Access Compliance Report

Public Rights-of-Way

(Curb Ramps)

Intersection ID: 11208	Main Street: PARKWOOD_AV	Cross Street: N_BREVARD_ST	Location: NW
ADA ID: 6D28F53DDC87	Ramp Type: Perp	Initial Pass/Fail: Pass	Overall Compliance: No
		Severity Score: 0

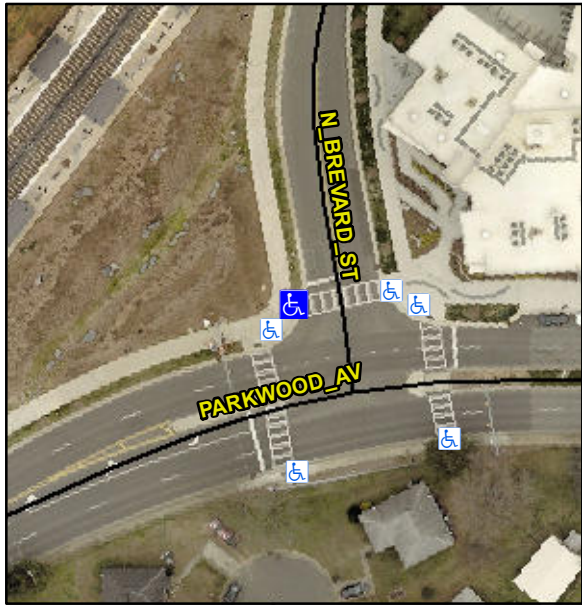
Codes/Mitigation Info/Possible Solution			Field Measurements/Component Compliance					
	Possible Solutions:		Compliance	Description	Data	Compliance	Description	Data
	Remove & Replace Landing.		N/A	Ramp Length (in)	71.0	Yes	Ramp Slope (%)	7.0
			Yes	Ramp Width (in)	48.0	Yes	Ramp XSlope (%)	1.0
			N/A	Flare Type LT	Sloped	N/A	Flare Type RT	N/A
			N/A	Flare Slope LT (%)	7.8	Yes	Flare Slope RT (%)	3.6
			N/A	Flare Traversable LT?	Yes	N/A	Flare Traversable RT?	Yes
			Yes	Landing Length (in)	48.0	Yes	DWS Provided?	Yes
			Yes	Landing Width (in)	48.0	Yes	DWS Contrast?	Yes
			Yes	Landing Slope (%)	0.6	Yes	DWS Length (in)	24.0
			No	Landing X Slope (%)	2.4	Yes	DWS Full Width?	Yes
<p>Surveyor Notes:</p> <p>N/A</p> <p>PROW/ADA:</p> <p>R304.5.3</p>			N/A	Landing Curb? (Y/N)	No	Yes	DWS Offset (in)	2.0
			N/A	Shared Landing?	No			
			Yes	Gutter Ponding?	No	Yes	Gutter Slope (%)	3.6
			Yes	Gutter Lip Ht (in)	0.0	Yes	Gutter X Slope (%)	0.8

N/A	Painted X Walk1?	Yes	N/A	Painted X Walk2?	N/A
				X Walk 1 Direction	To E		X Walk 2 Direction	N/A
			N/A	X Walk 1 Width (in)	116.0	N/A	X Walk 2 Width (in)	N/A
				X Walk 1 Slope (%)	2.2		X Walk 2 Slope (%)	N/A
				X Walk 1 X Slope (%)	1.9		X Walk 2 X Slope (%)	N/A
			Yes	Ramp inside XWalk1?	Yes	N/A	Ramp inside XWalk2?	N/A
			Road Slope (%)	N/A	N/A	Clear Space?	Yes	
			Road X Slope (%)	N/A	N/A	Clear Space to XWalk (in)	N/A	
		Yes	Any Obstructions?	No	Yes	Storm Grate/Utility Hazard?	No	
			Obstruction Type			Storm Grate/Utility Type		
					N/A		N/A	
					Yes	Surface Condition? (G/P)	Good	
Total Cost:		\$	500.00
